Submissions and Amendment Report

*STACK SYDo1 Data Centre,
Erskine Park (SSD-82211208)*

Figure 2 Zoning Map

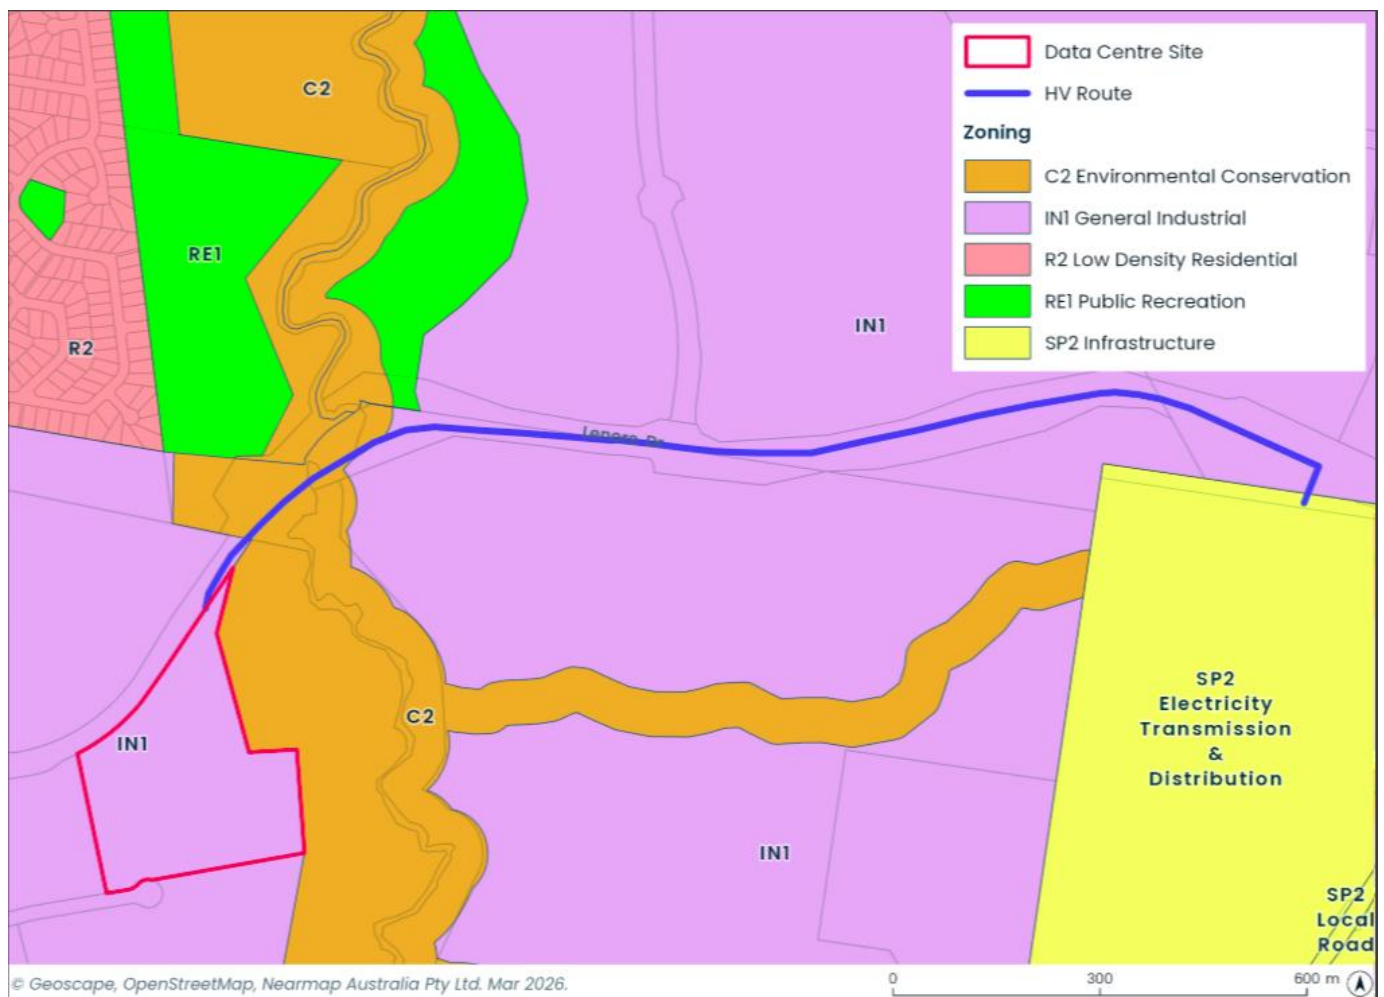
It is highlighted that the HV route, or any works associated with its construction, will not encroach on any private land.

A map showing the data centre site and the off-site HV cabling route is provided at **Figure 2**.

Figure 3 Proposed Cut and Fill Plan

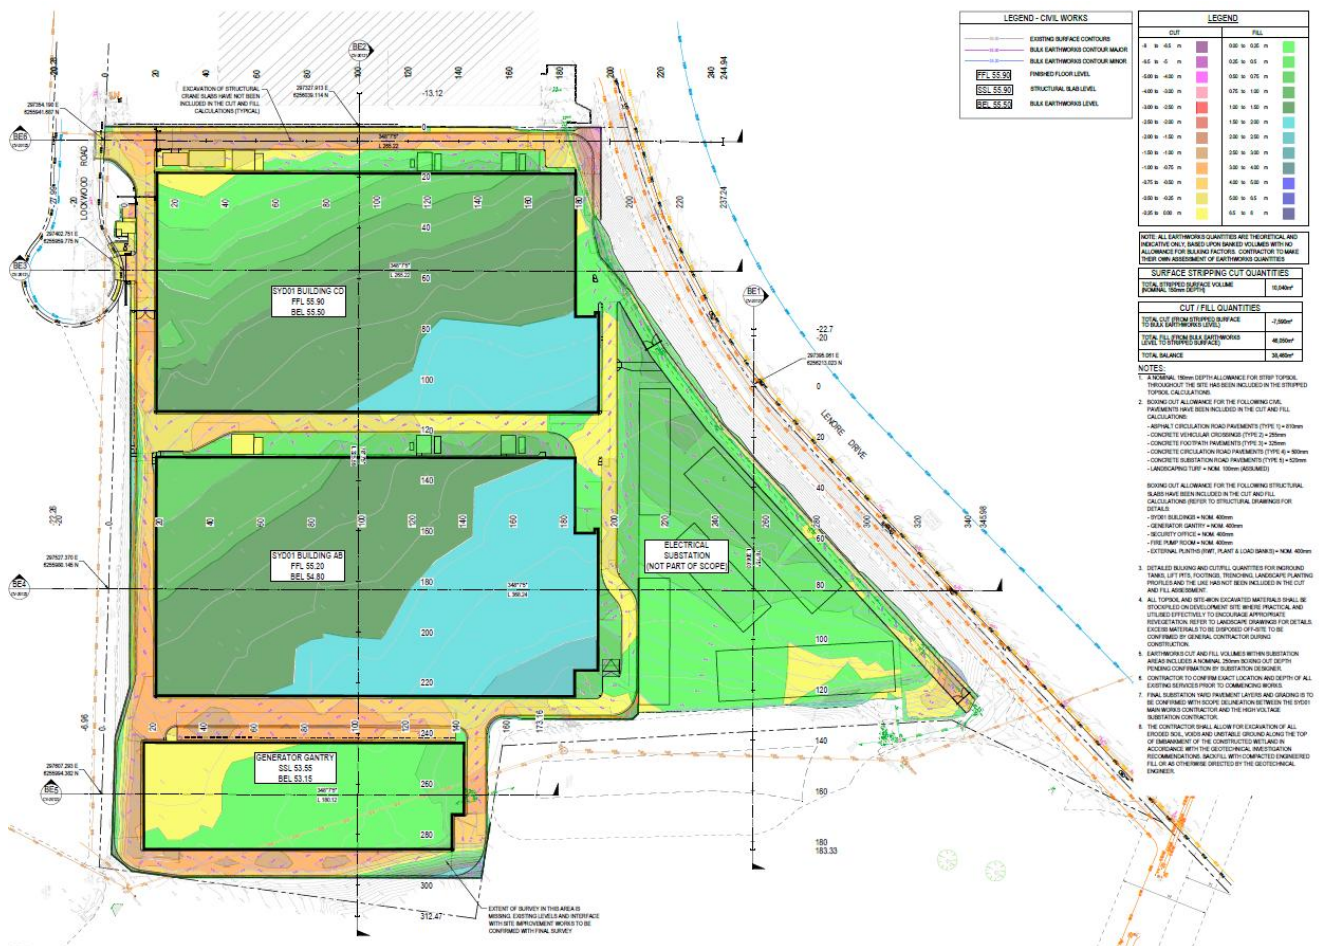
The revised proposal introduces retaining walls of up to 2 metres in height along sections of the eastern and southern internal roads associated with revised levels and road alignments.

The earthworks strategy has been informed by the need to minimise unnecessary ground disturbance, while ensuring efficient coordination with the broader precinct's road network, servicing strategy, and urban design objectives. An extract of the revised cut and fill plan is provided in **Figure 3**.

Figure 4 Comparison of Original and Amended Site Layout

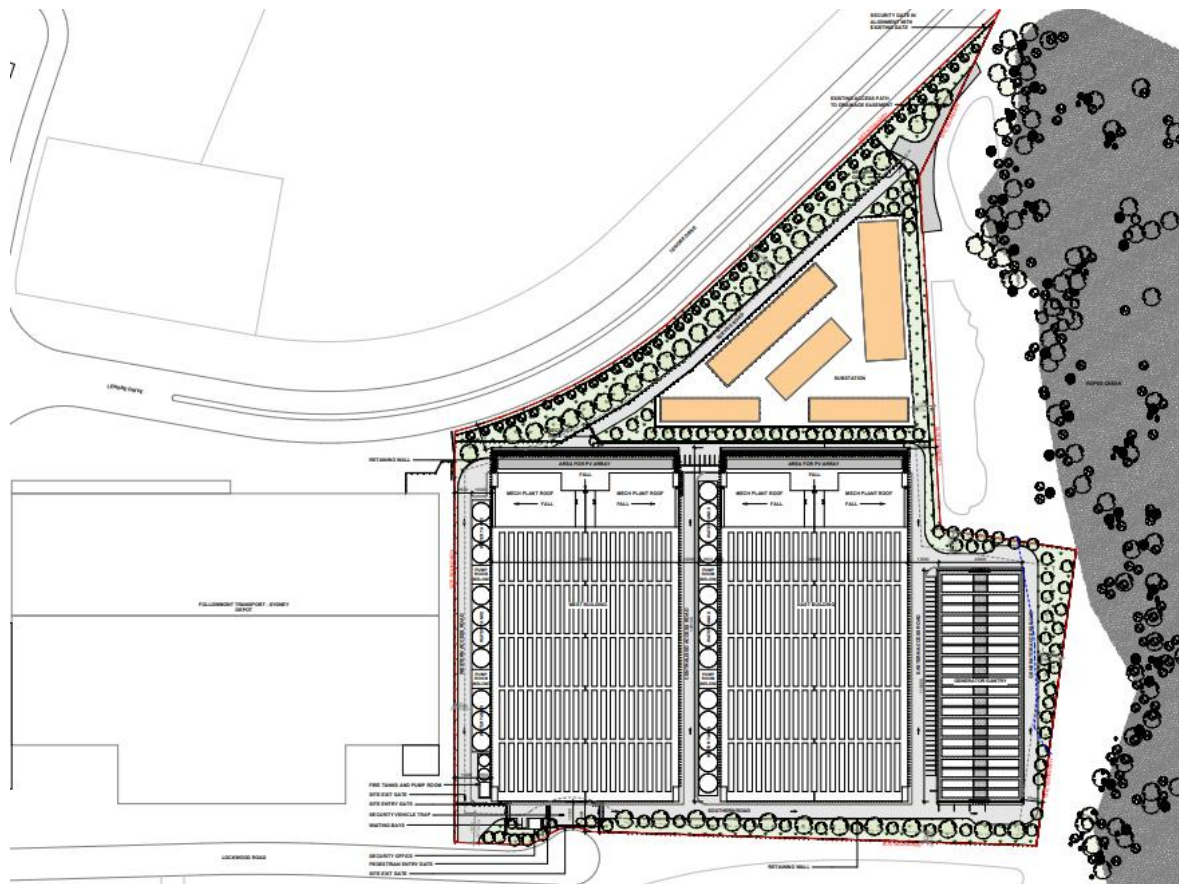
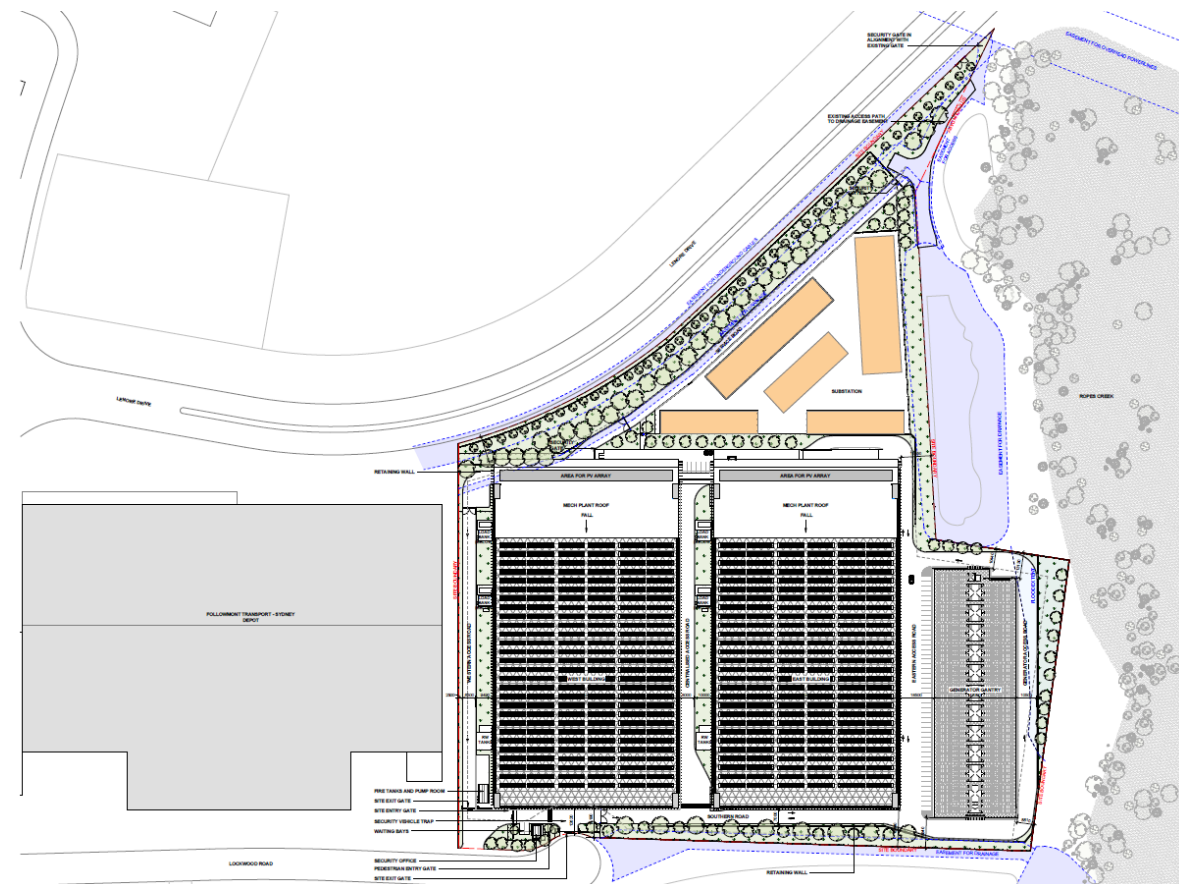
The removal of the water tanks has resulted in a revised separation between the two data centre buildings of approximately 18 metres. While this is reduced from 21.6 metres, the previous arrangement included tanks within this space, resulting in a more limited effective separation. The amended layout continues to present as two distinct buildings, consistent with the original design intent.

Minor refinements have been made to the ancillary office floorplans, including adjustments to room layouts, lobbies and plant areas, as well as the introduction of a circulation corridor connecting the two buildings at upper ground level. These changes do not affect the external appearance, bulk or scale of the development.

Figure 5 Comparison of Original and Amended Internal Office Layout (Upper-Ground Level)

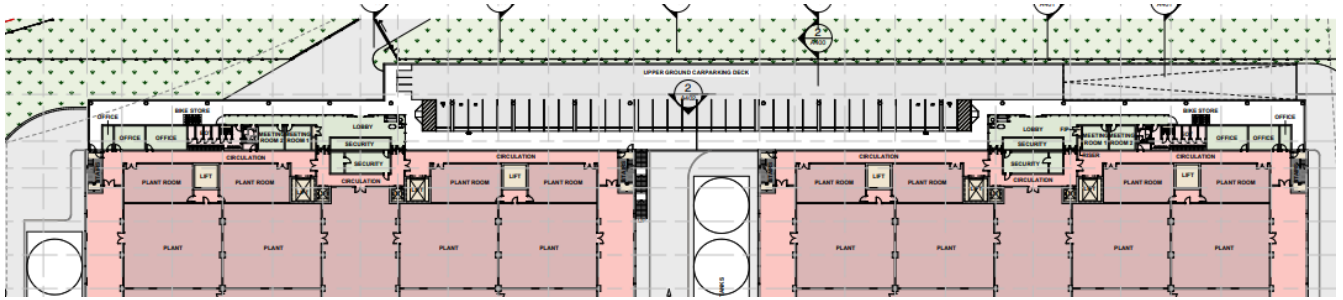
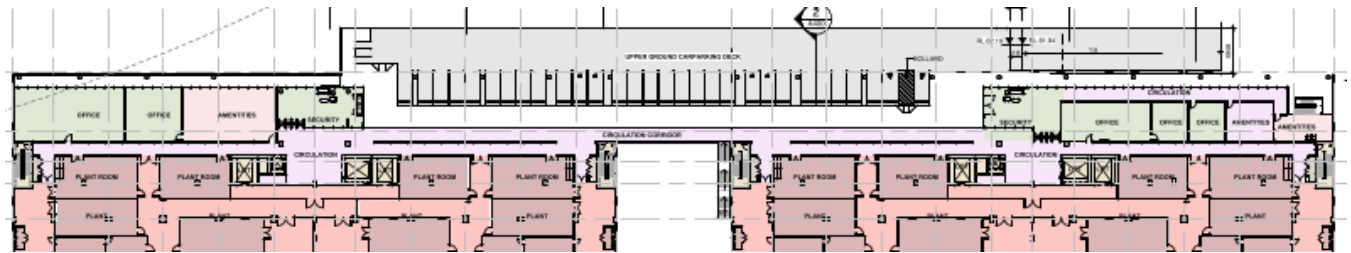
- Minor internal refinements to the ancillary office floorplans, including the introduction of a corridor connecting both buildings at Upper Ground level.

Figure 7 Updated Circulation Strategy

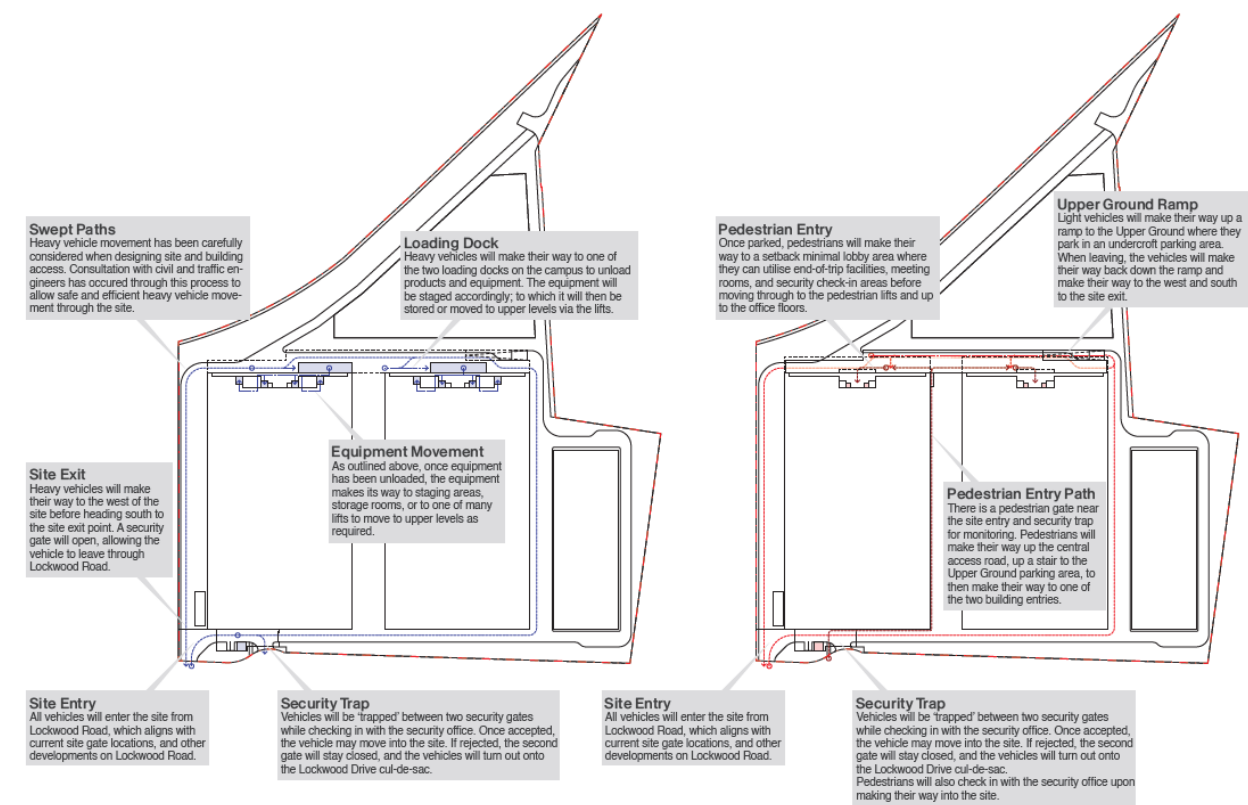
The amended proposal includes minor refinements to the internal access and circulation network to improve functionality and efficiency. Key changes include conversion of the eastern and southern internal roads to two-way operation, realignment of the northern road, and adjustments to the northern vehicle ramp. These refinements improve internal vehicle circulation and site operations. An updated access strategy diagram is provided at **Figure 7**.

The changes also result in minor adjustments to internal separation distances between built elements and circulation areas, including increased separation between the eastern data centre building and the generator gantry. There are no changes to site access points, the external road network, or the number and arrangement of car parking spaces.

Figure 8 HV Cabling Route Map

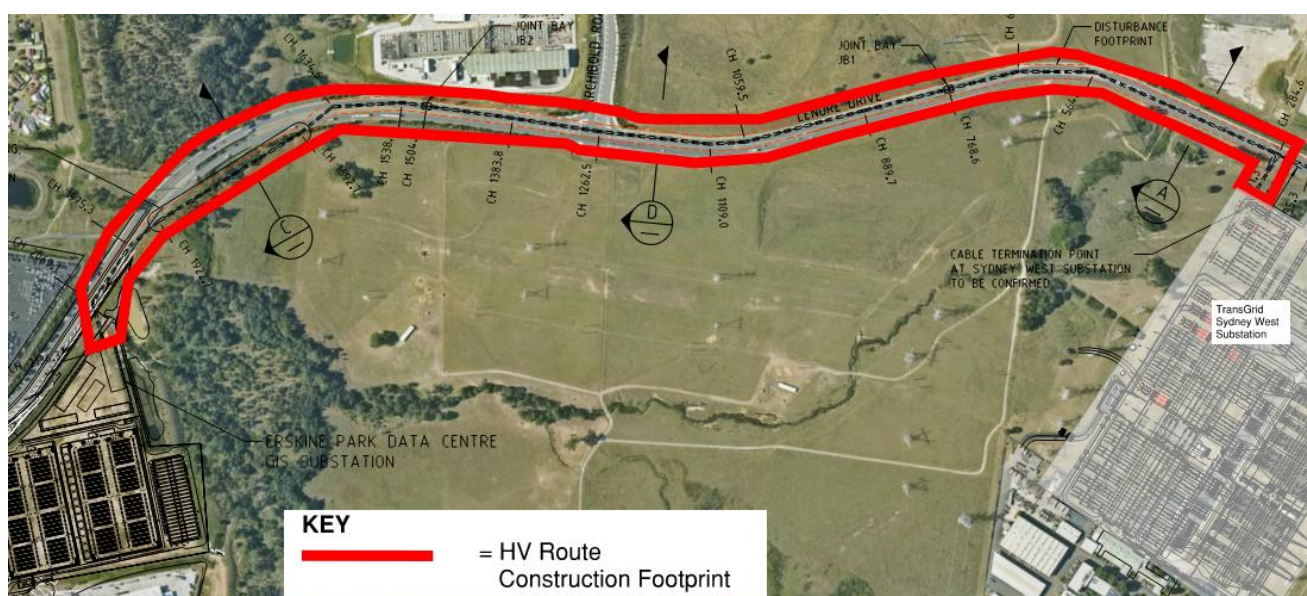
Since the SSDA was publicly exhibited, the Applicant has also undertaken further consultation with TransGrid/Lumea regarding the external HV works required to support the data centre. In response, the proposal has been amended to incorporate the HV connection within the scope of the SSDA, including additional land and works beyond the main site at 78 Lockwood Road to facilitate two 330kV transmission lines from the TransGrid Sydney West Substation along a 2.1km route within the Lenore Drive road reserve.

This amendment is required as TransGrid has advised it cannot deliver the works under Part 5 of the *Environmental Planning and Assessment Act 1979* (**EP&A Act**) due to competition law and ringfencing requirements.

Figure 13 Extract of Site Plan highlighting increased western setback and landscaping between buildings

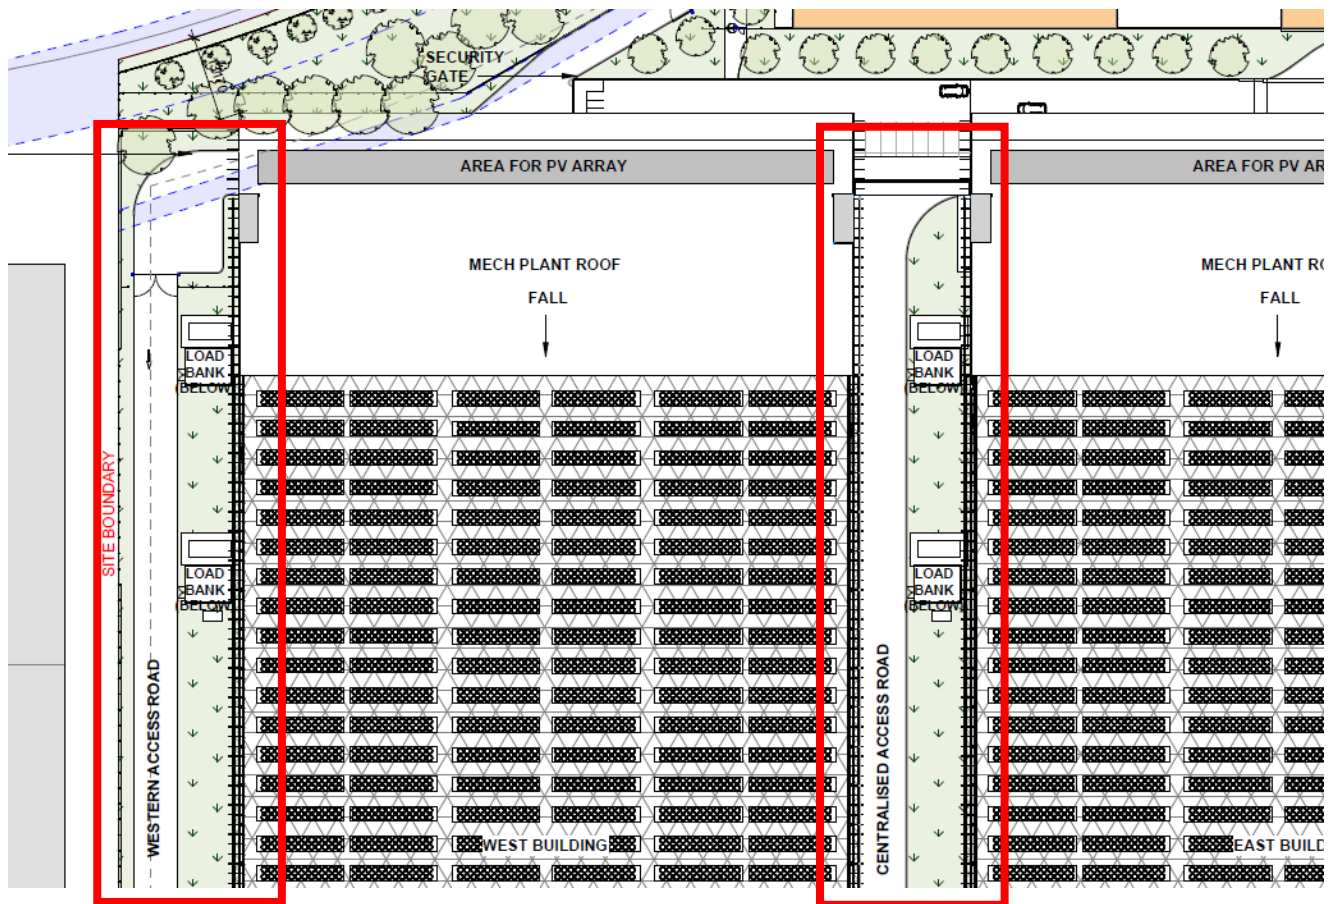
The amended proposal does not introduce any changes to building height or bulk that would alter overshadowing impacts relative to the original proposal. Minor adjustments to building siting and layout are limited in extent and do not result in any material change to shadow patterns. As such, overshadowing impacts remain consistent with those previously assessed and are considered acceptable.

Overall, the amended layout represents a refinement of the original design that maintains the key built form parameters while improving site planning and landscape outcomes. In particular, the removal of the industrial water tanks and consolidation of plant has enabled increased setbacks, additional deep soil areas and enhanced landscaping, improving the interface with surrounding land and the overall visual presentation of the site. Accordingly, the amended proposal represents an improved urban design outcome compared to the original scheme, without giving rise to any additional impacts.
